Service Bulletin 507

Affected Models Thunderbird Commander and Thunderbird LT

Subject Additional PDI Checks

Exhaust Heat Shield Fixings

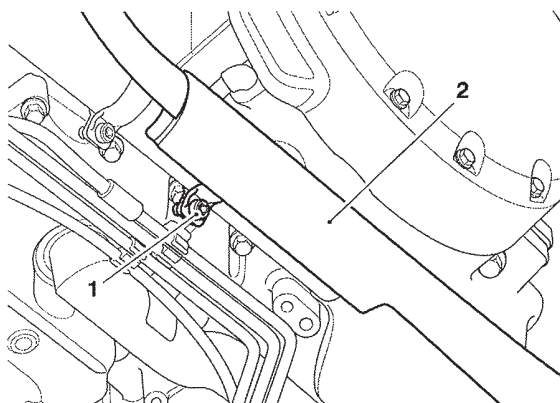
1. Check and, if necessary, tighten the fixing for the left and right hand front exhaust heat shields to **9 Nm**.

Brake Hard Line Clips Replacement

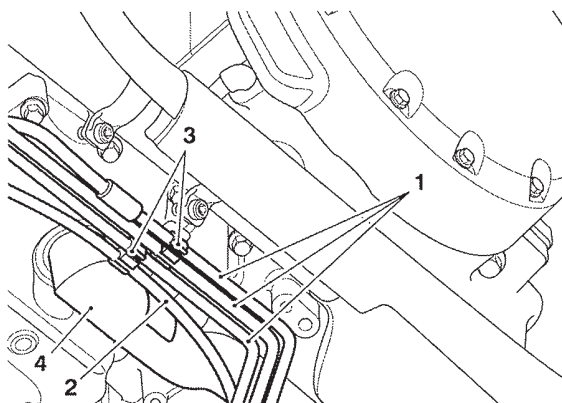
1. Detach the three brake hard lines and the clutch cable from their clips located on the bracket near the coolant pipe under the engine.

2. Using suitable pliers, remove the two plastic clips from the bracket.

1. Clip
2. Rivet

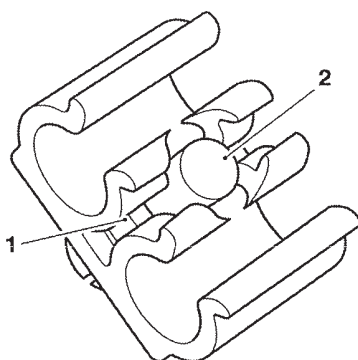
Do not use excessive force or a hammer to tap in the plastic rivet of the new clips. Use a suitable pin punch and push in the plastic rivet.

3. Position the new clips onto the bracket as noted for removal.
4. Using a suitable pin punch, carefully push in the plastic rivet until it clicks into position and is flush with the base of the clip.

Reroute Right Hand Oxygen Sensor Harness

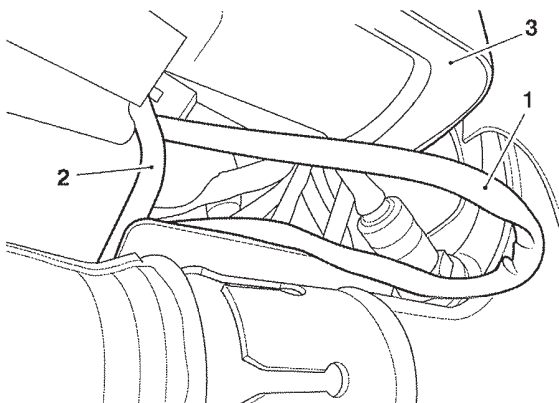
2. Locate the harness for the right hand oxygen sensor and gather all the slack. Move the slack in the oxygen sensor harness to the left hand side of the radiator, ensure the harness is positioned behind the brake hard line.

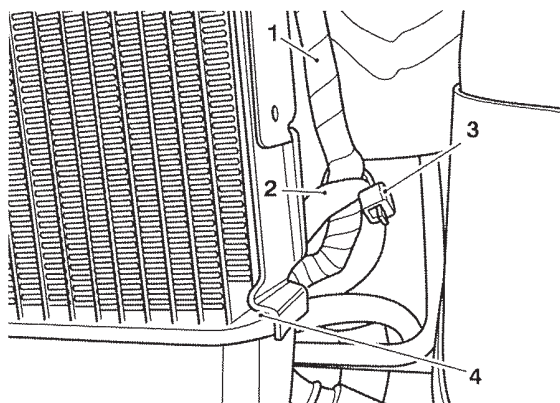
3. Secure the harness for the right hand oxygen sensor to the main harness with a cable tie, as shown below. Cut off any excess cable tie.

Harness Repair

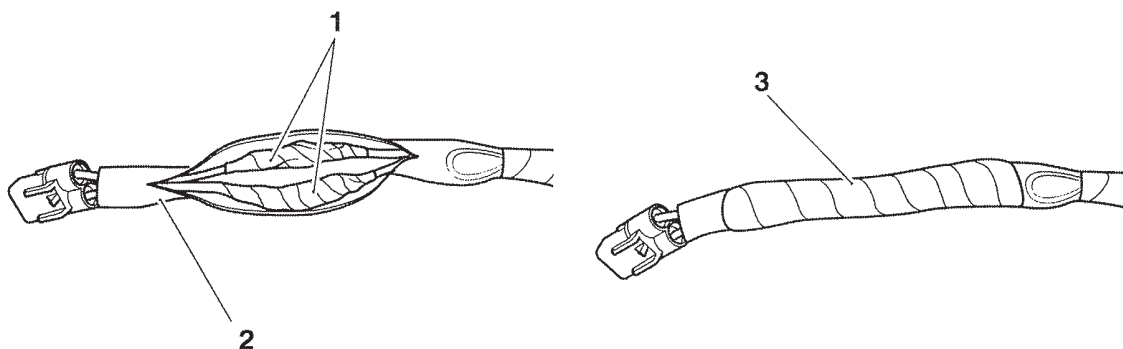
7. When the wires have been repaired or are serviceable, cover the wires with the harness covering and use black insulating tape to completely cover the slit, as shown in the illustration below.

Routing of the Harness

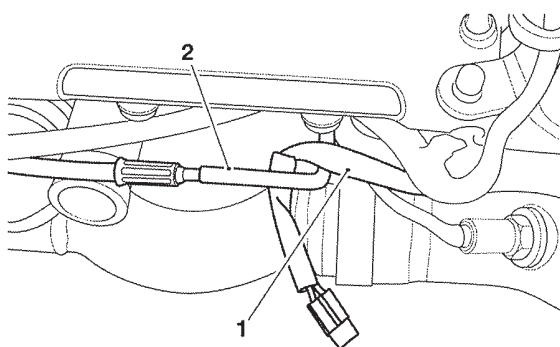
8. Route the cooling fan part of the main harness over the top of the brake line, as shown below (radiator shown removed for clarity).

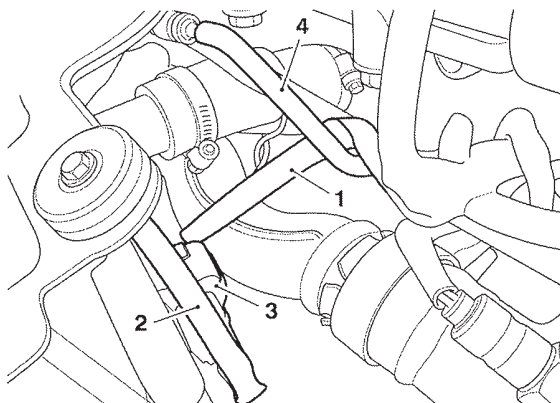
10. Ensure the cooling fan harness is routed as shown below, noting that the harness must pass over the brake hard line.
